Guelph/Eramosa Township Hydrogeology Agency Review Document Book

Hydrogeology Review Document Book Index

**Re: Harden Letter of June 10, 2014
Project No.: 300032475.0000**

M15 Hydrograph

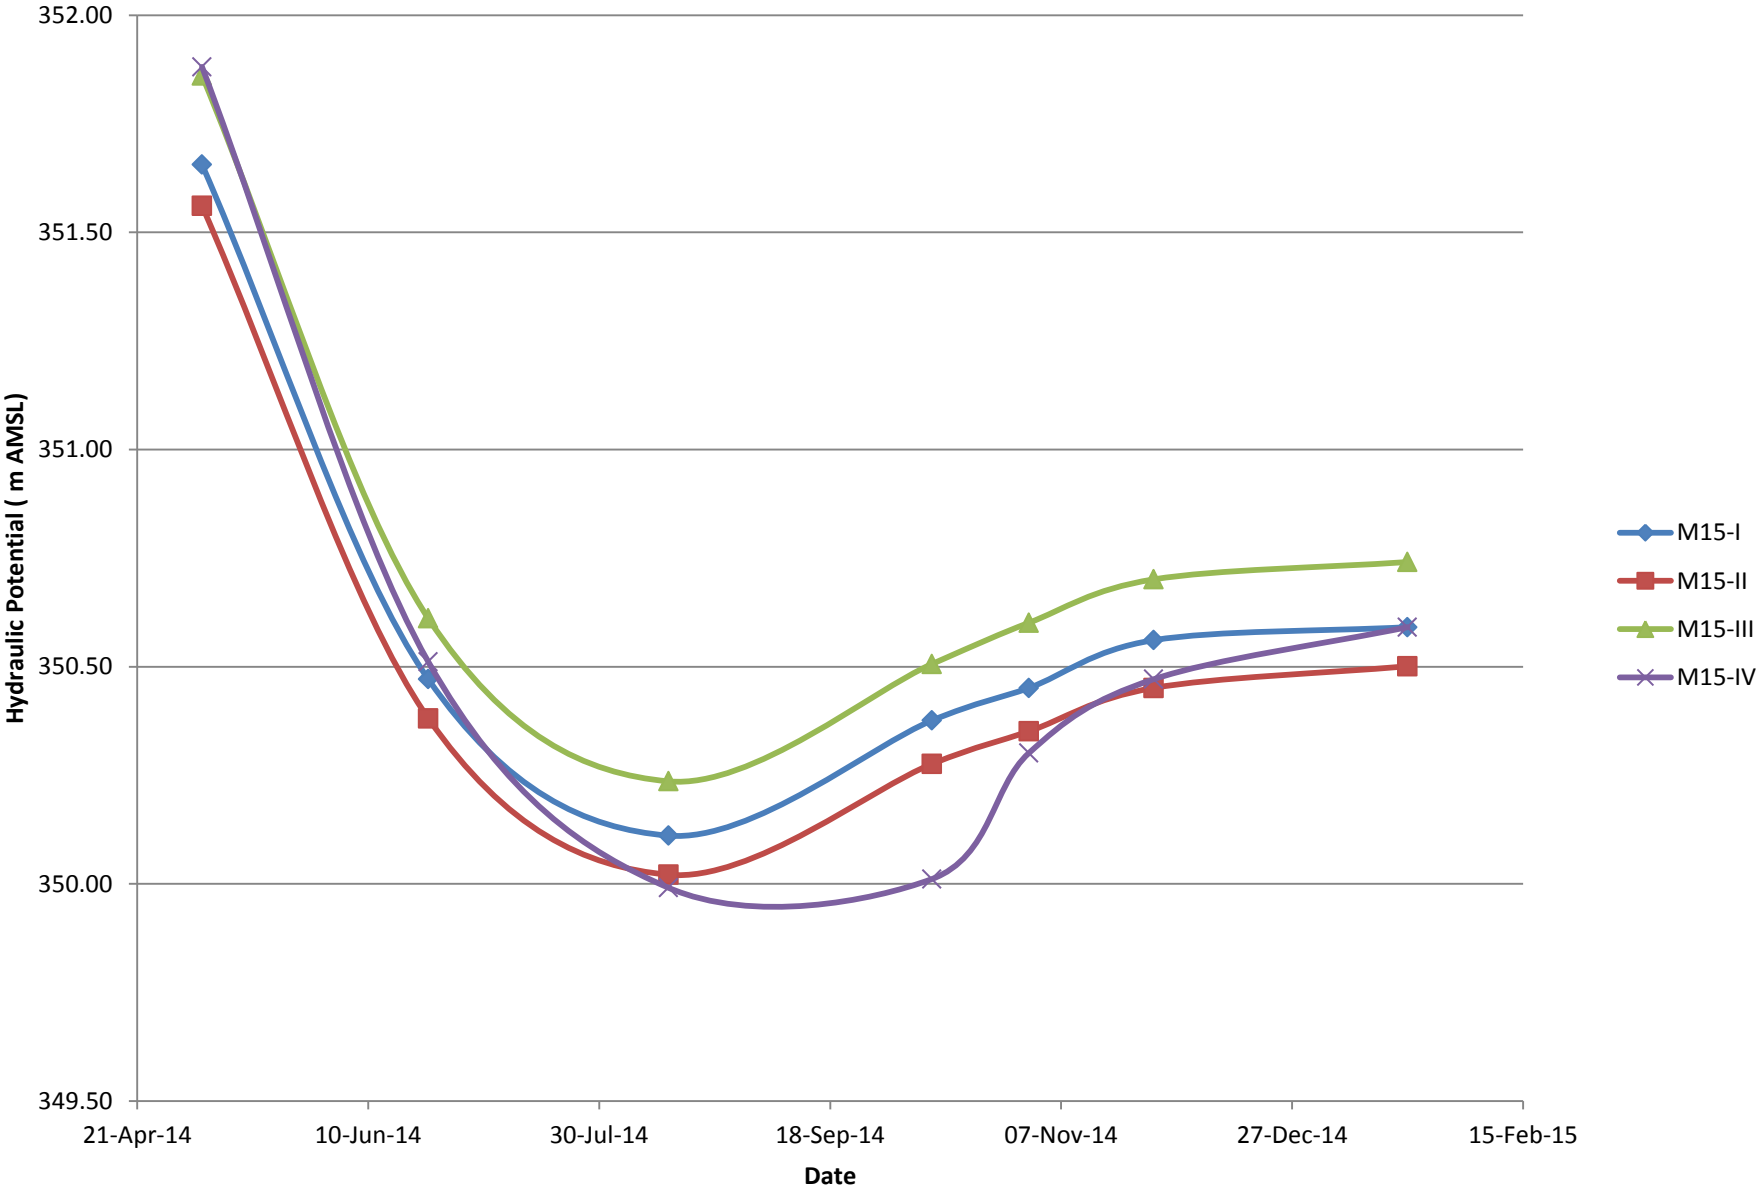
Alternatively if you prefer, please provide us with 2014 hydrograph plots for all monitors with similar horizontal (time) scale to that of M15.

Drawdown in metres for Scenario 1

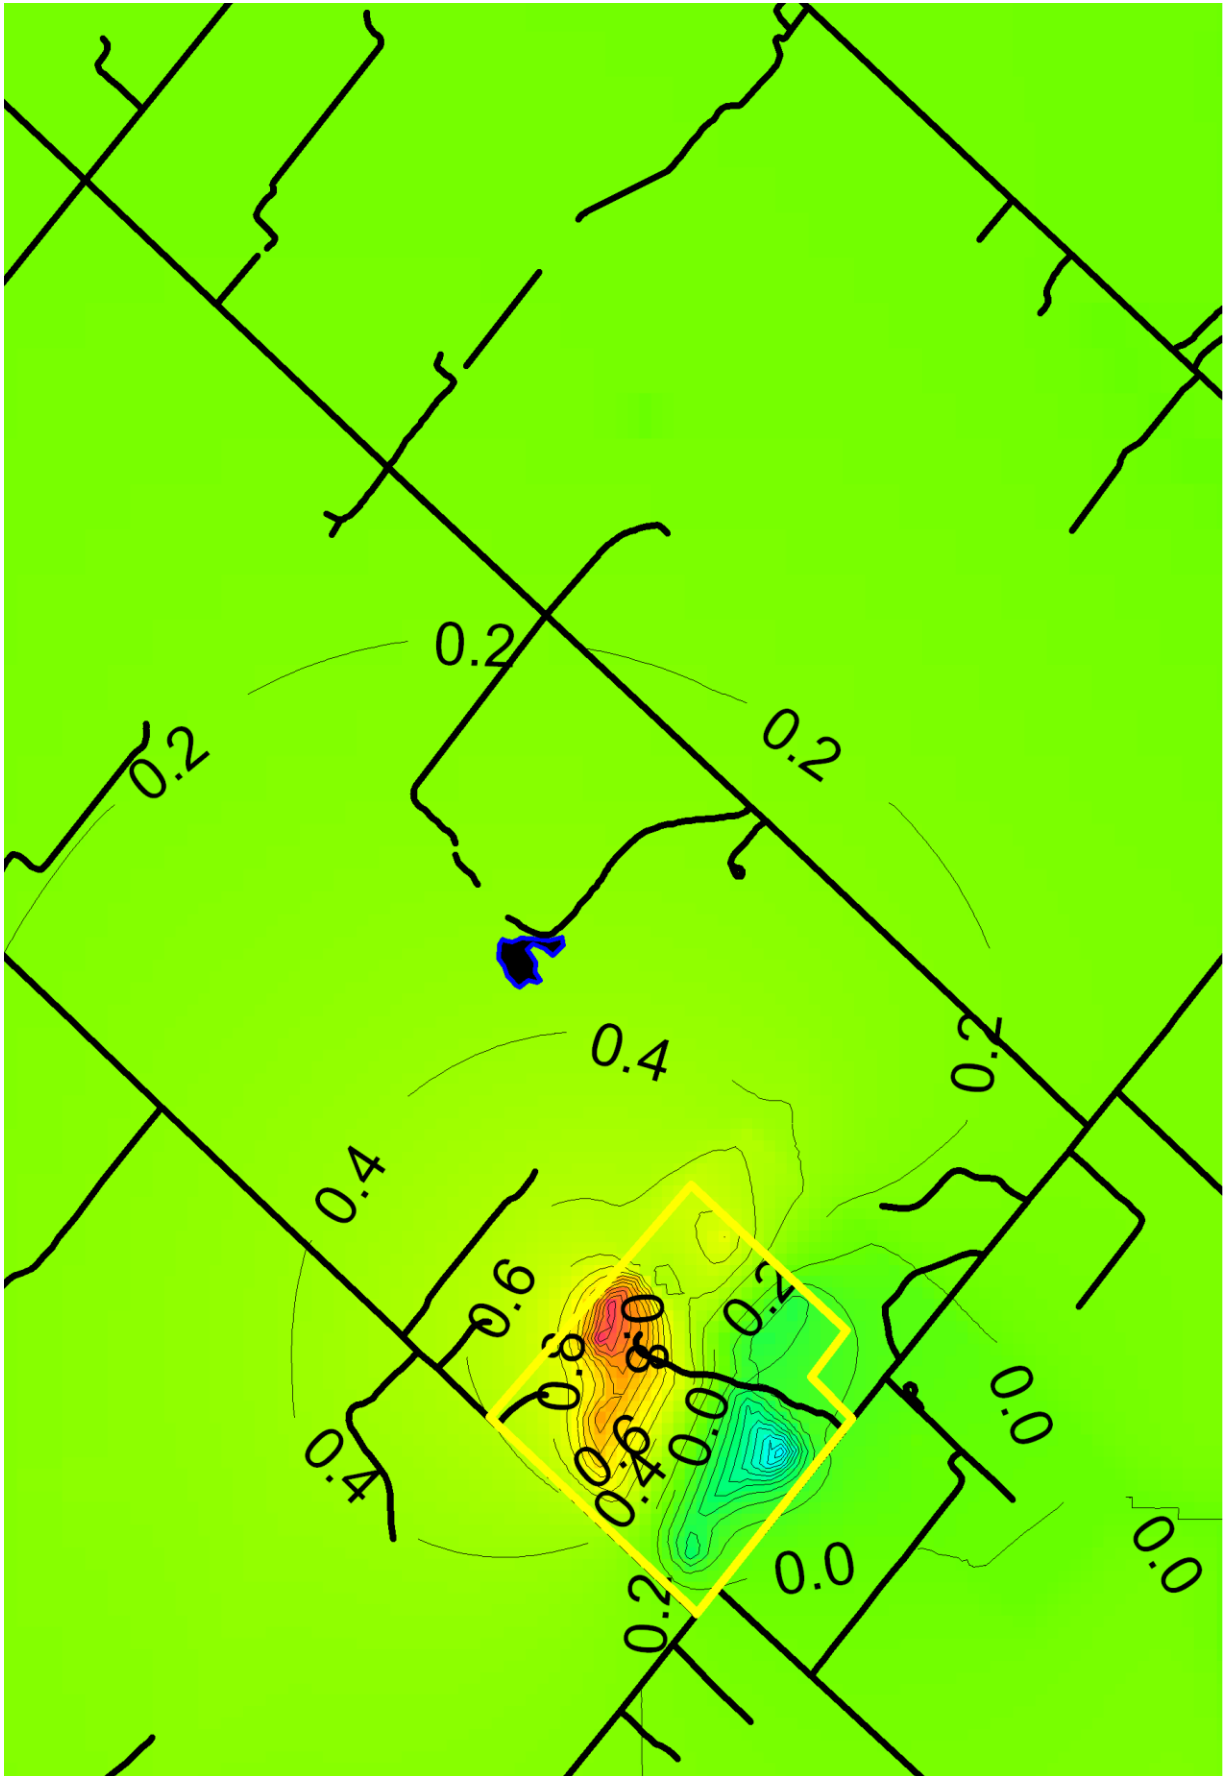
2. s2.2 pg 3 Revised Model Potential Impacts

No potential impact visuals are provided to review predicted drawdowns for the now 'revised' groundwater model. Example W3 used for analysis is not a critical well.
